Updated PD state diagram v200

33.3.3.5 State diagrams

Change Figure 33–16 as follows:

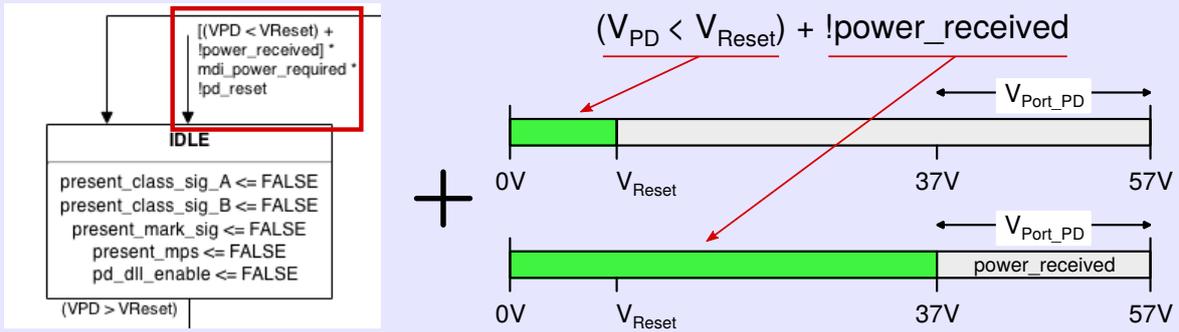
Any open arrow (an arrow with no source block) represents a global transition. Global transitions are evaluated continuously whenever any state is evaluating its exit conditions. When a global transition becomes true, it supersedes all other transitions, including UCT, returning control to the block pointed to by the open arrow.

In other words: unless a PD is powered, the SM will continuously flip back to the IDLE state. This entry arrow into IDLE has existed since 802.3at
